34 BUSBY STREET PLANNING PROPOSAL

File No: 20.00373

The purpose of this report is to provide Council's initial assessment of the Planning Proposal lodged in relation to 34 Busby St, South Bathurst to determine if Council supports progression of the Planning Proposal to the NSW Department of Planning, Housing and Infrastructure (DPHI) for a Gateway Determination to enable public exhibition of the planning proposal.

Figure 4 – Landscape Plan submitted for DA 2020/50

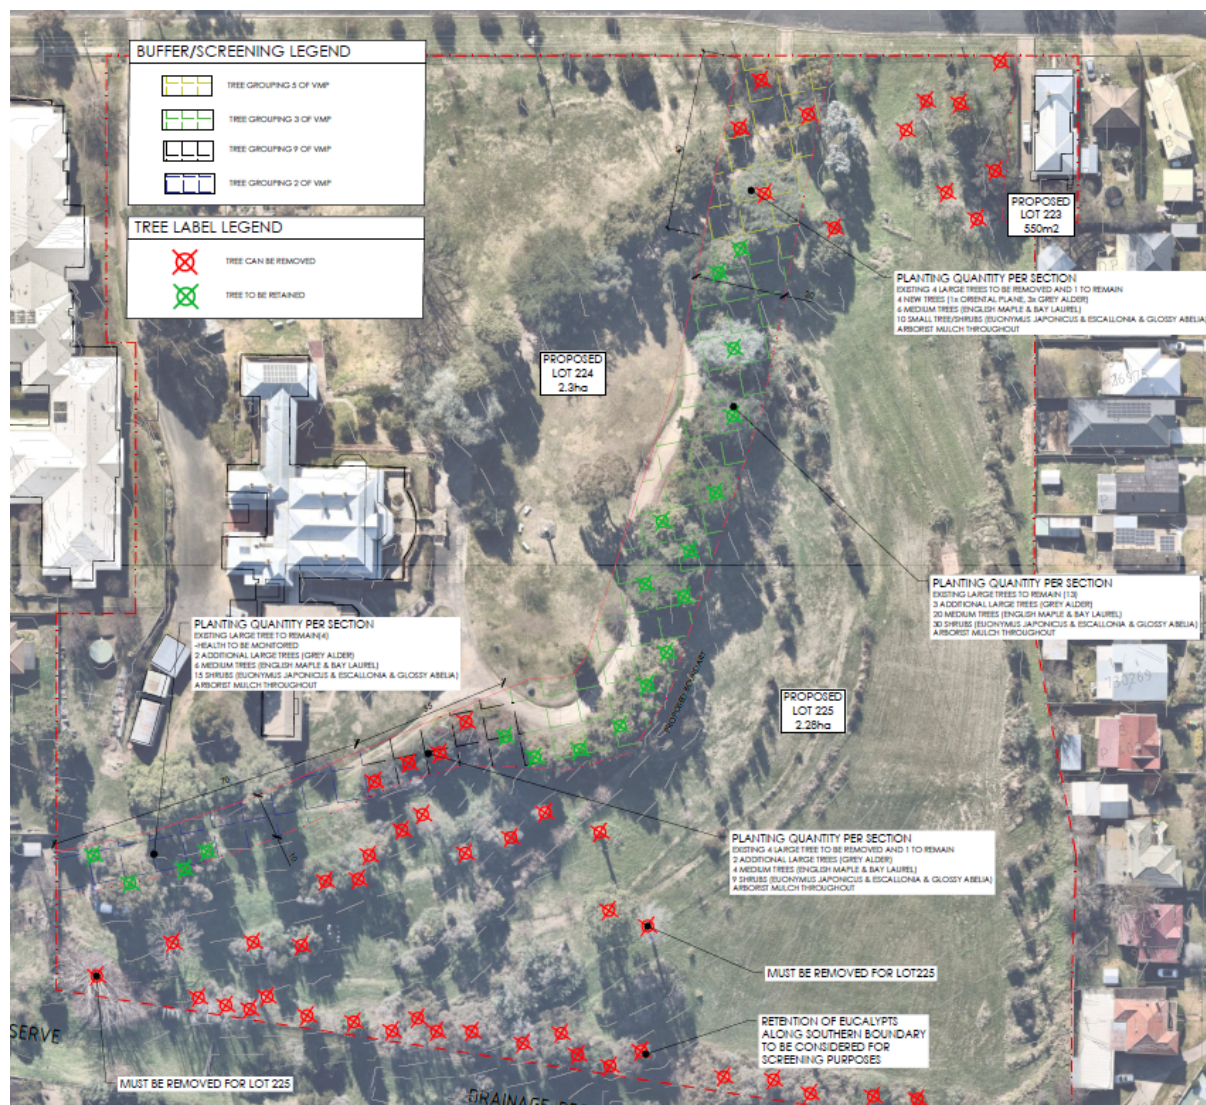
The VMP and the Landscape Plan relates to the Planning Proposal because they identify that there are a number of trees with low significance that are suitable for removal, and some trees that are of low significance but can be considered to be kept for screening

Figure 9a – Setbacks diagram (Marchese Partners | Life^{3A}, 2024)

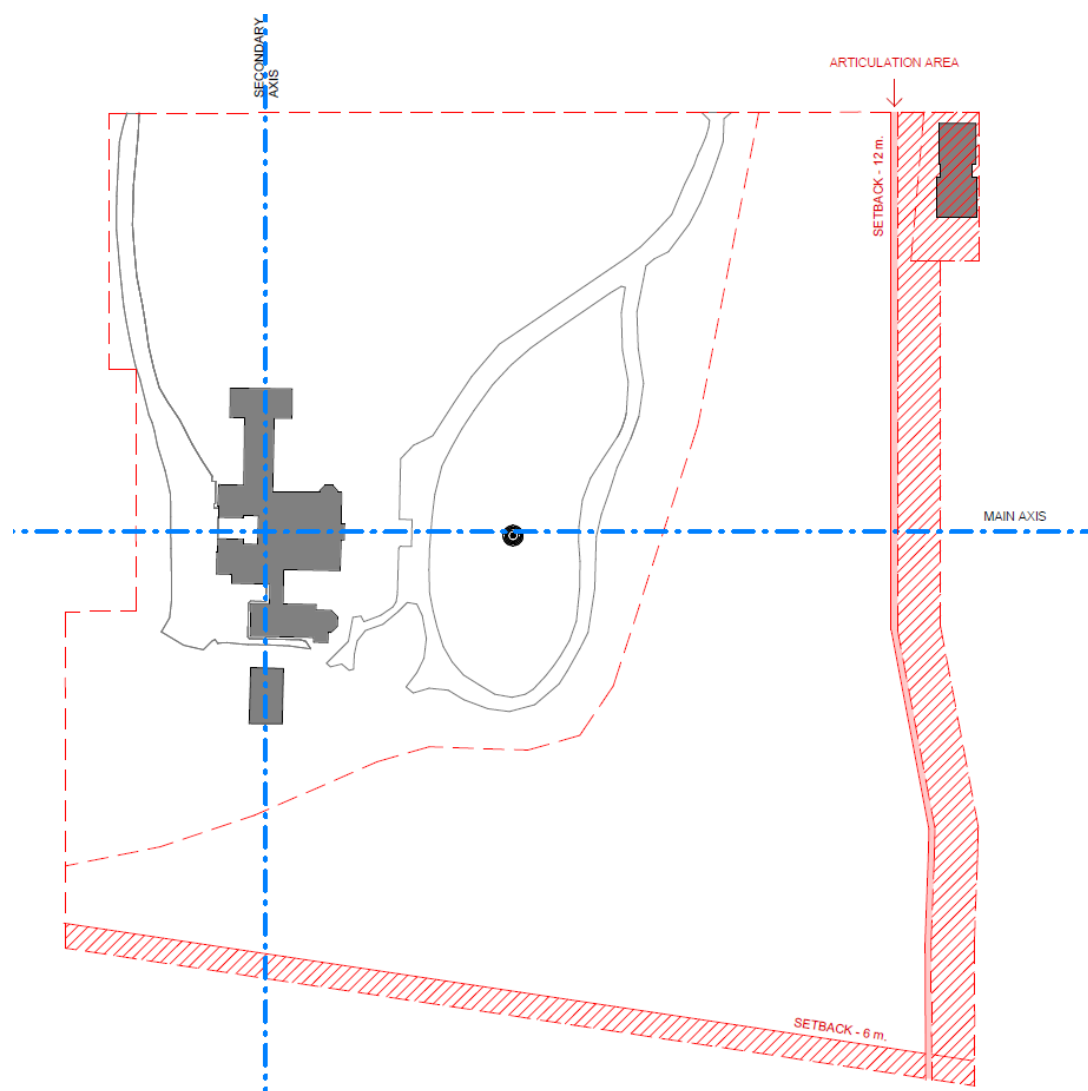
The proponent's place analysis determined that there are no setbacks applicable to the development. In consideration of the recommendations of the CMP, the building locations were sited with respect to preserving St Joseph's Mount's view corridor. Setbacks were established 6m from the southern boundary, and 12m to the eastern boundary.

The setbacks at the Busby Street frontage appear to be undefined in the Master Plan, possibly zero. The side setback to the Gatekeeper's Cottage allotment appears to envelope part of its boundary in order to create vehicular access, resulting in a side setback from 3m to 8m, inclusive of a 1.5m 'articulation' zone that traverses the entire side boundary setback proposal. This articulation zone is to allow for some flexibility in the built form.
